HP 9133/9134 D/H/L Service Manual

Manual part number: 5957-6560

Service Note History

Required Screws in Exchange Flexible

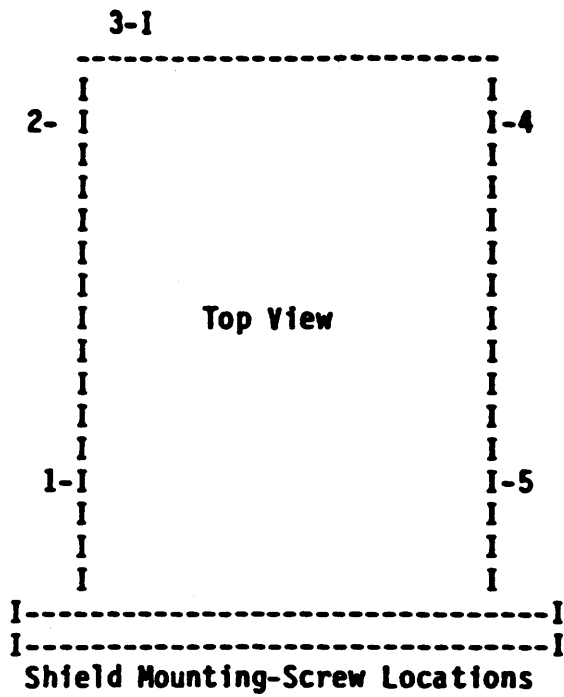
The 09114-69511 Flexible Disc drive is currently used in three products; the 9114A, the 9122D/S, and the 9133D. There are 5 possible locations for mounting-screws that attach the shield to the frame of the drive. Each product requires a different minimum number of screws. In some cases, screws must NOT be installed in certain locations.

All drives in the 9133D's have been shipped with the proper mounting-screws. However, many of the EXCHANGE drives shipped prior to September 1984 contained only the one rear mounting-screw. The exchange drive is now being shipped with the MAXIMUM number of screws to accommodate all products that use the drive.

The 9133D requires screws in locations 2 and 3 ONLY. Screws 1,4, and 5 MUST BE REMOVED.

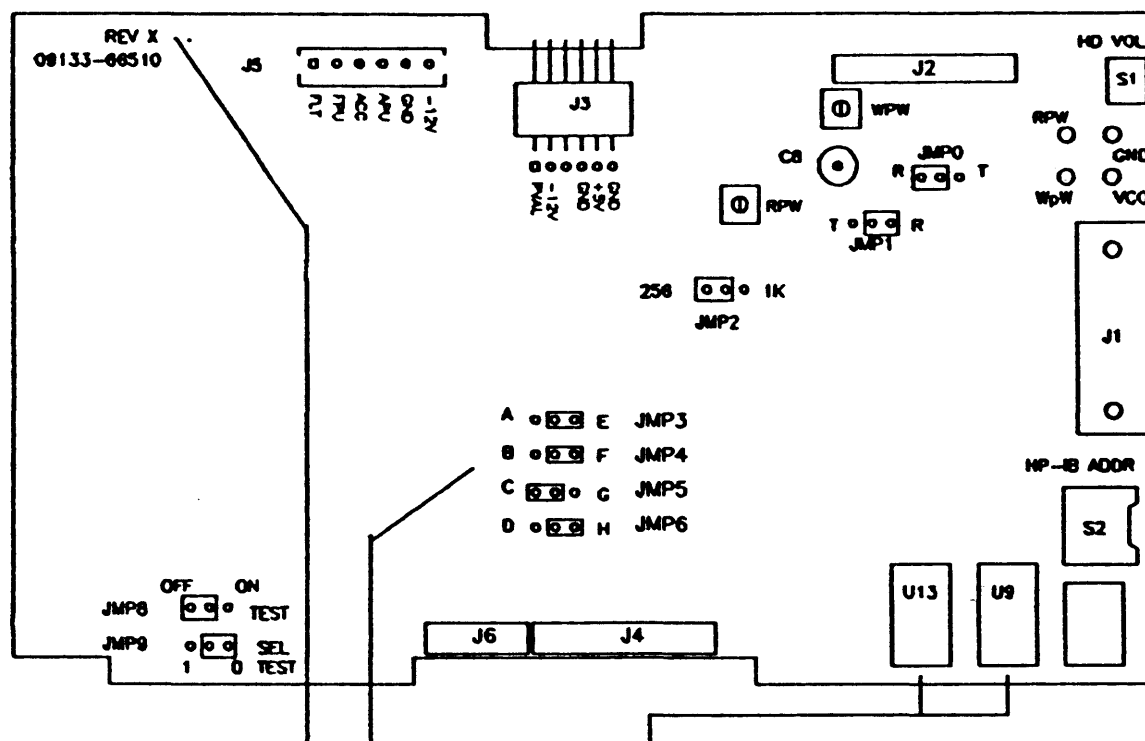
A revised controller PCA is being shipped in all 9133D Disc Drives. The new controller will be in 9133D products beginning at approximately serial number 2419A14750. This controller will also be shipped in all 9133D products with serial number prefix of 2511A and above.

The controller assembly has been revised to use a single IC to perform the hard disc controller and ECC functions which were previously performed by two IC's. Additional changes include a change to a different IC for the phase lock loop for the hard disc, and silkscreen changes to correct an error on the original PCA.

Both the Rev B and the Rev C controller assemblies will be used as exchange assembly 09133-69520. All service inventory of the original exchange assembly 09133-69510 must have firmware updated per service note 9133D-4 before being used to service any 9133D Disc Drives with serial number prefix 2511A or above. Firmware should not be updated in 9133D Disc Drives which are repaired.

Jumpers JMP3-JMP6 must be installed as shown in the figure on the next page to assure correct operation. Note that the jumper configurations shown here differ from those shown in the service documentation for the 9133D.

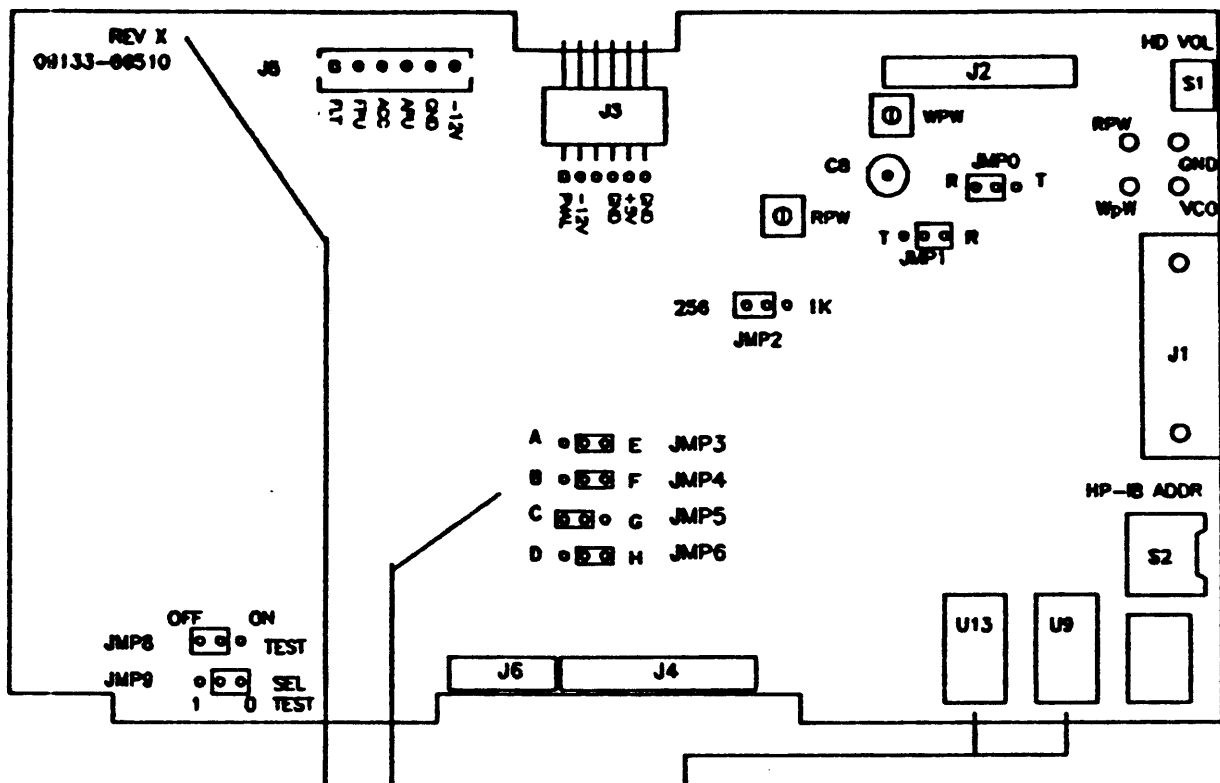
The 09133-69520 Controller PCA which is used in the 9133D, 9133H, 9134D, and 9134H may be a board which has '09133-66510 Rev B' or '09133-66510 Rev C' etched on the board. Jumpers JMP3-JMP6 must be configured properly for the product in which it is installed. Please note that the correct jumper configuration is determined by the product in which it is installed and the revision letter on the PC assembly.

Set JMP3-JMP6 as shown in the figure on the next page to assure that the jumpering is correct for the product in which the controller PCA is installed. Also note that JMP2 will have to be changed when a controller PCA is installed if the disc drive is option 001.
